21 February 2020

EnergyAustralia

Australian Energy Market Operator - Draft 2020 Integrated System Plan

Figure 16 Announced retirements and corresponding builds in Central scenario to help firm VRE

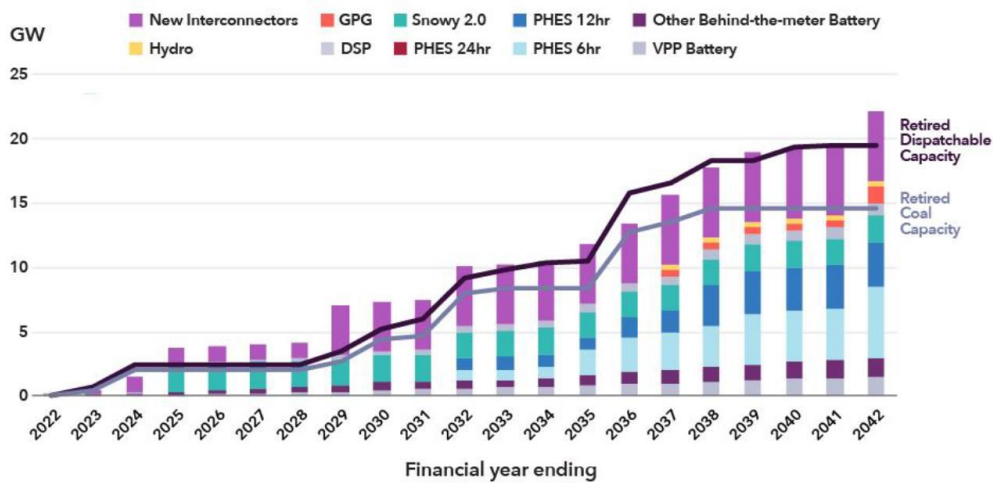
The draft ISP's presumed reliance on interconnectors is likely to affect stakeholder expectations of how large amounts of variable renewables will be accommodated into the system from a technical perspective. For example, Figure 16 of the draft ISP report includes installed interconnector capacity alongside new and retiring firm generation, which is potentially misleading; it may give a false sense of security as dispatchable capacity via interconnectors is a function of available capacity in exporting regions, which will not necessarily be available when required.

In our view, AEMO is aggressive in its projections that place heavy reliance on transmission interconnection to make up for a loss of dispatchable generation capacity. It represents a relatively extreme risk position from a reliability perspective that is at odds with the increased political and societal focus on reliability. We are concerned practically it may lead to state of increased market intervention.

Figure 70 Victoria – forecast maximum operational demand 19/01/2040, Central scenario

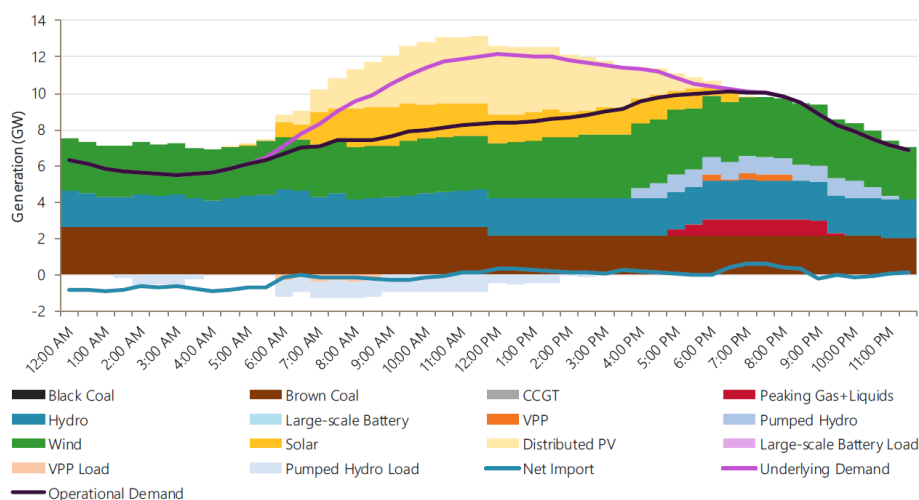
While we appreciate the detailed intra-day regional maximum demand charts in section 4.5 of the ISP Appendix, they do not address our concerns regarding future system reliability as they don't represent expected conditions of low wind at times of peak demand.

The variable renewable output on these charts appears much higher than AEMO’s published firmness assumptions for renewables. AEMO should explain these deterministic outcomes in the context of the firmness assumptions and release details of modelling that considers system operation under tight supply conditions created by limited firm generation as well as time periods associated with high demand.
